Amendment After Final Rejection
Application No. 10/718,751
Attorney Docket No. 062829

AMENDMENTS TO THE CLAIMS

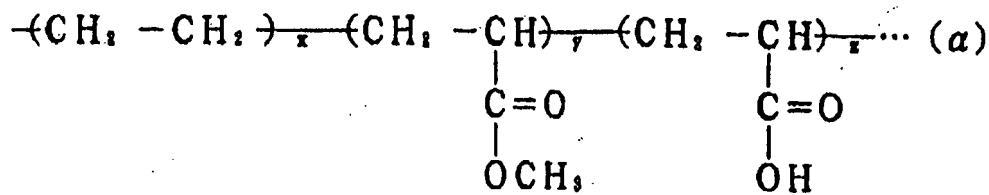
5. (Currently amended) A flexible hose of claim [[4]] 1, wherein the first rubber layer comprises an acryl group unit formula:

wherein, $x = 29.9 \sim 74.9$, $y = 25 \sim 70$, $z = 0.1 \sim 18$ and a carboxyl group is a crosslinking group.

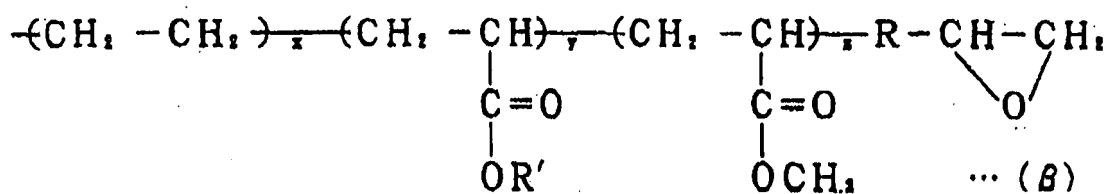
6. (Currently amended) A flexible hose of claim [[4]] 1, wherein the first rubber layer

wherein, $x = 29.9 \sim 74.9$, $y = 25 \sim 70$, $z = 0.1 \sim 10$, and further wherein R is hydrogen or ethyl group and R' is alkyl group with carbon number 1~18 and an end epoxy group is a crosslinking group.
